**Preliminary Alternative Technical Concepts (ATC) Submittal**  
**BEL-70-9.35 Interchange Improvement**  
**Design-Build**  
**Belmont County, Ohio**  
**PID 120547**

## Contents

EXHIBIT E

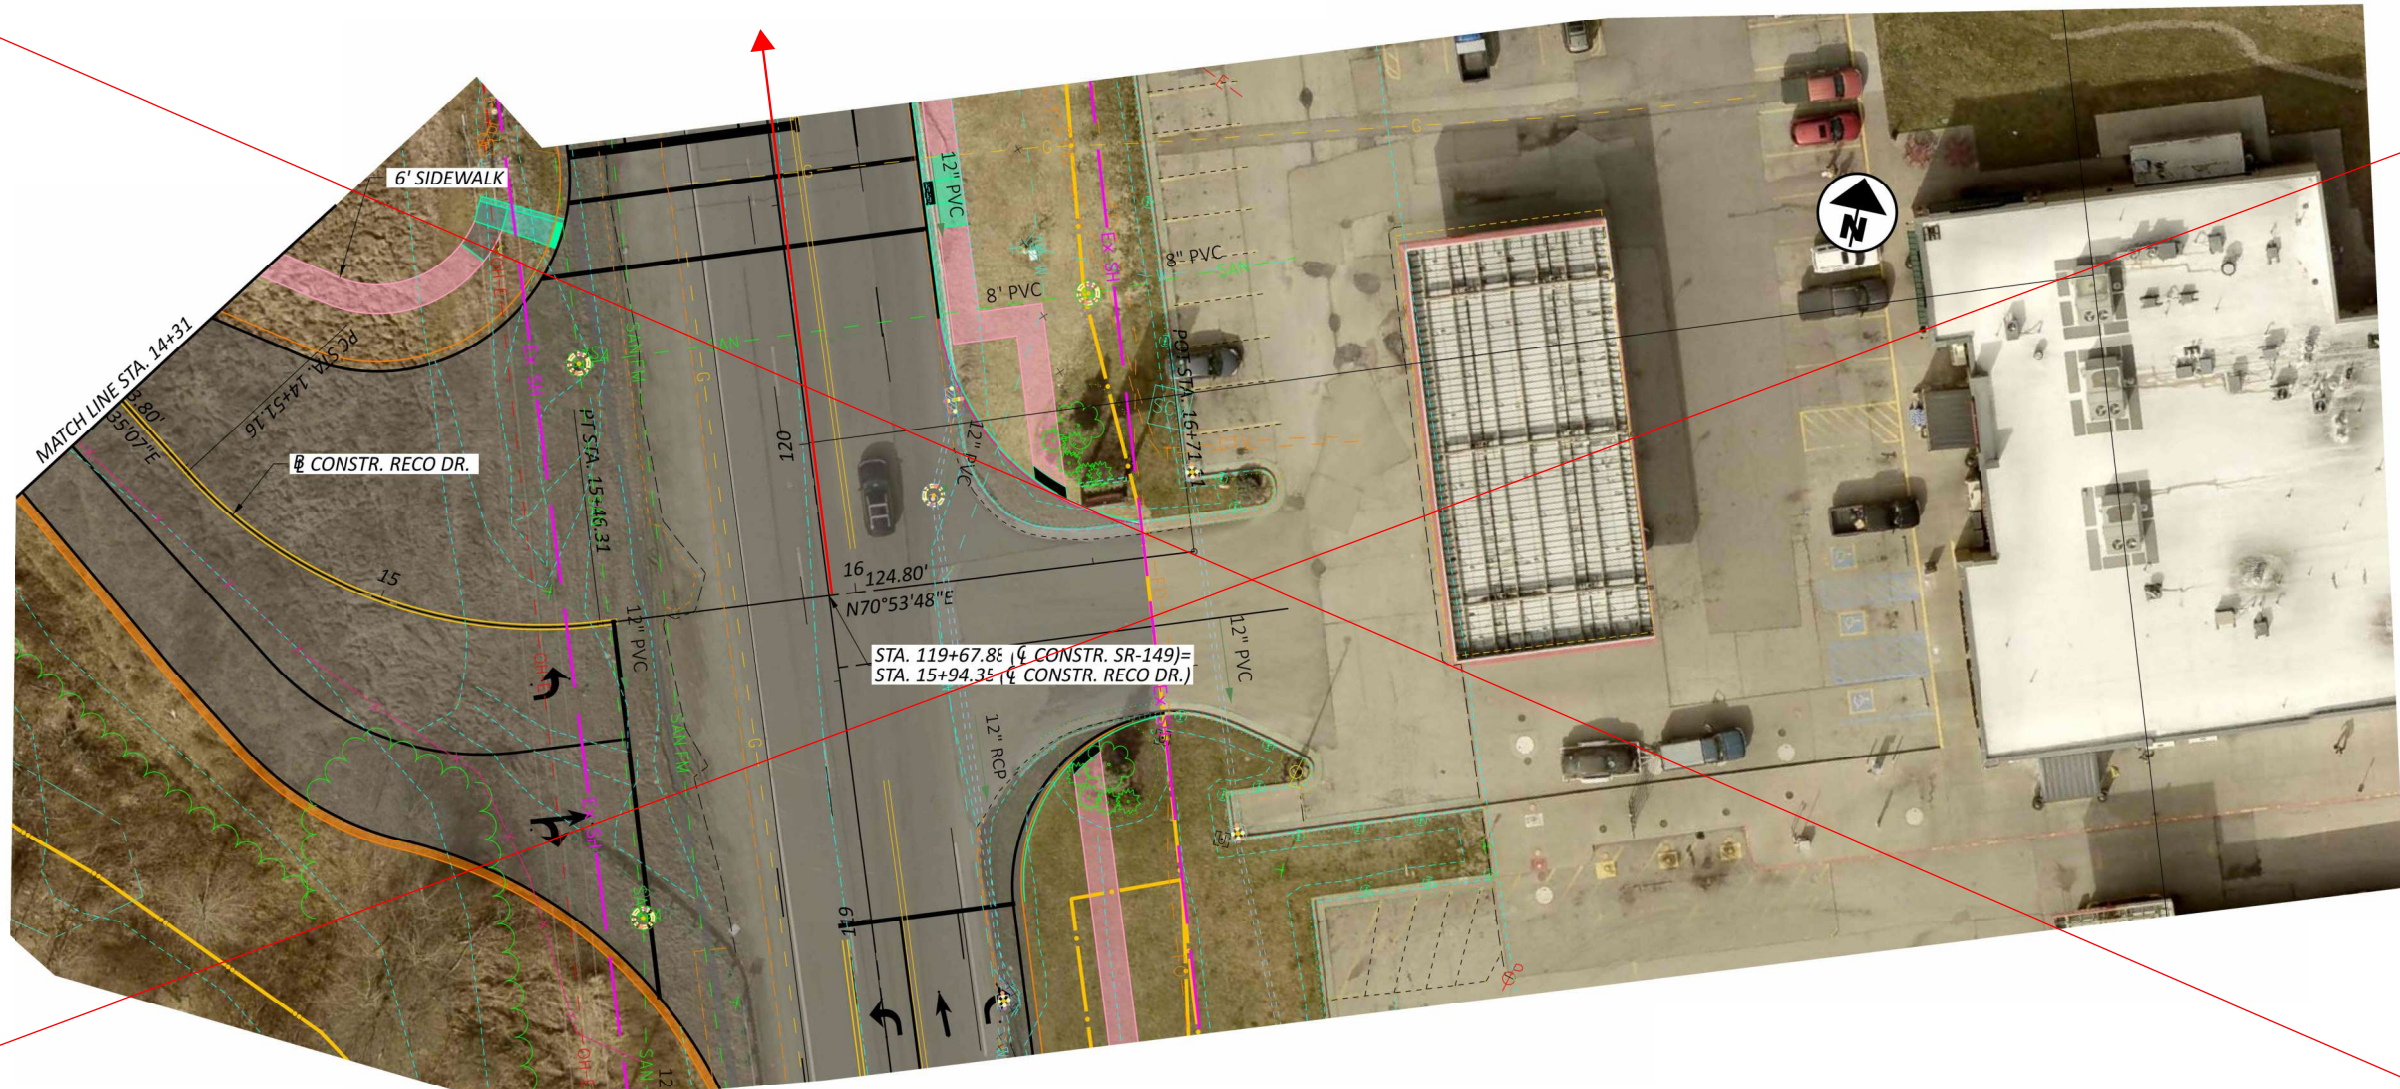
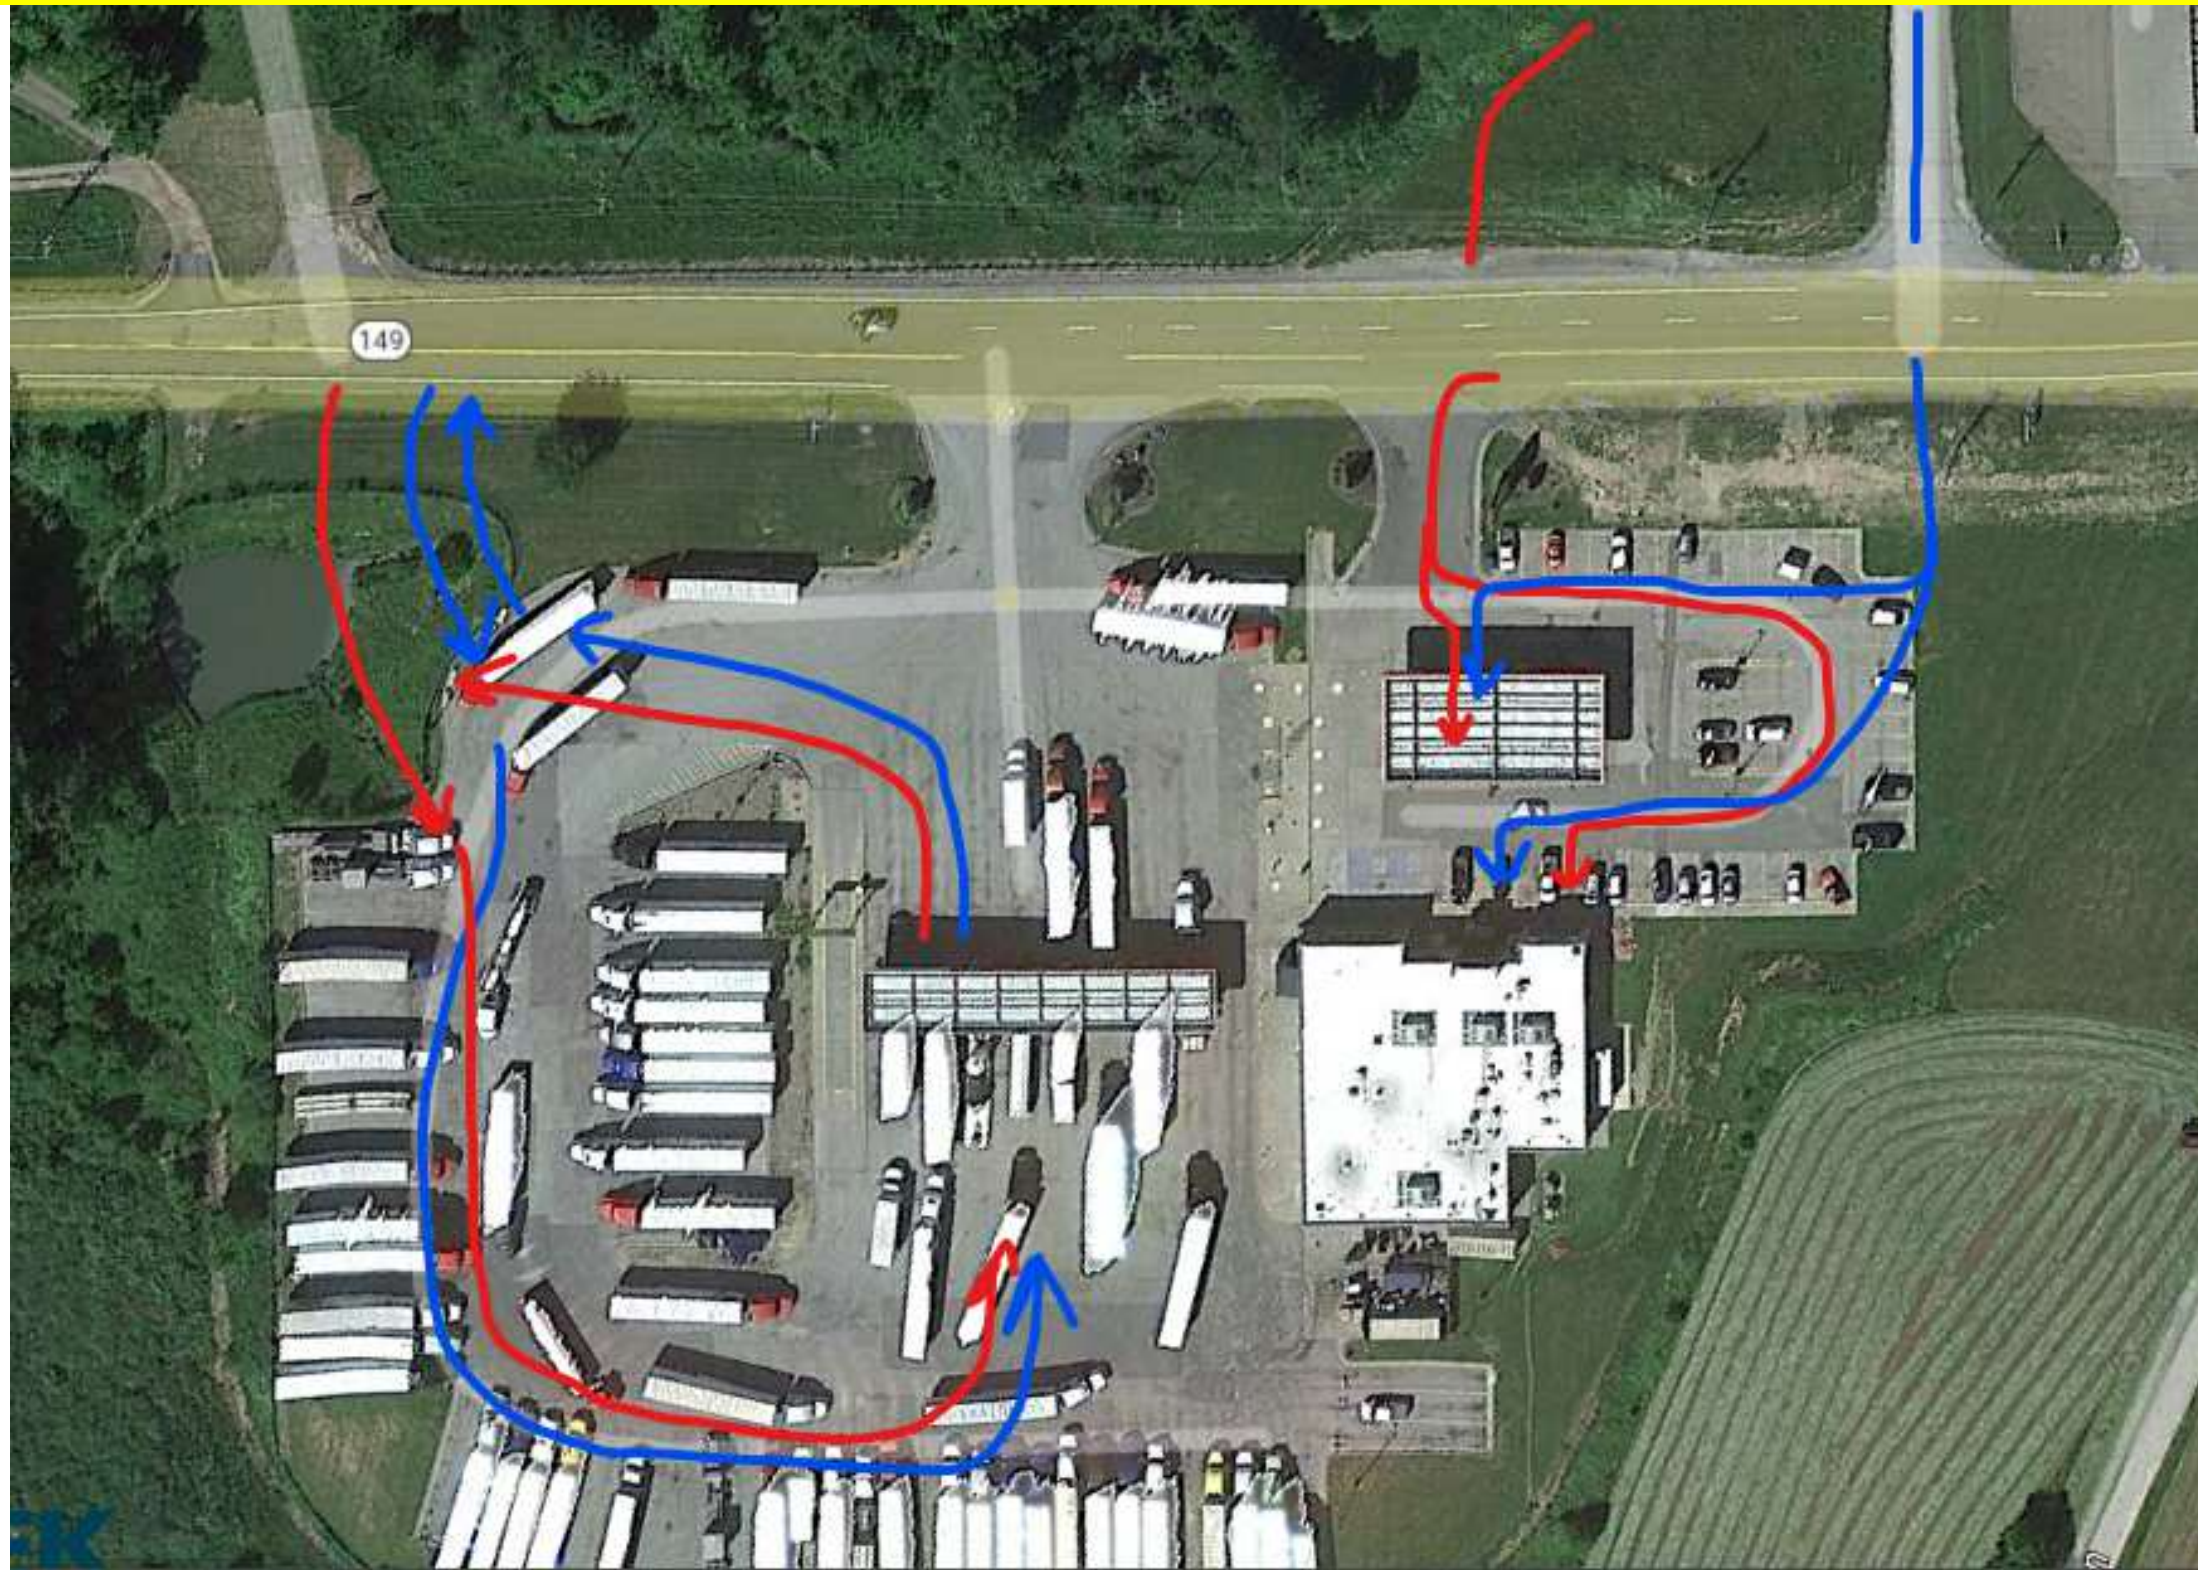
1. **Description:** This ATC proposes a modification to the driveway configuration requirements as outlined on Page 39 of 63 in the BEL-70-9.35, PID 120547 SCOPE OF SERVICES (Addendum 1). The original specification mandates that the DBT follow the geometrics depicted in the Conceptual Plans regarding proposed driveway configurations and existing driveway removals.

The DBT proposes to modify this requirement to design the driveways with input from the driveway owners. This modification allows for greater flexibility in aligning the existing Reco Drive with the new driveway configuration, rather than requiring a full realignment of Reco Drive. By working with local stakeholders to determine an optimal geometric design, this change aims to minimize construction impacts, reduce costs, and improve overall traffic flow while still maintaining functionality and accessibility for adjacent properties. See Exhibit E for additional details.

2. **Deviation:** Page 39 of 63 in the BEL-70-9.35, PID 120547 SCOPE OF SERVICES (Addendum 1) states: "*The DBT shall follow the geometrics depicted within the Conceptual Plans in regard to proposed driveway configurations and existing driveway removals.*"

The DBT proposes to modify the above language to: "*The DBT shall design Reco Drive to the ODOT Location and Design Manual Volume 1 and maintain a signalized intersection. The intersection point of Reco Drive and DR-2 shall be between Sta. 119+00 and 121+50. DR-3 and/or DR-5 may be eliminated, combined, or relocated by the DBT due to the proposed proximity to Reco Drive.*"
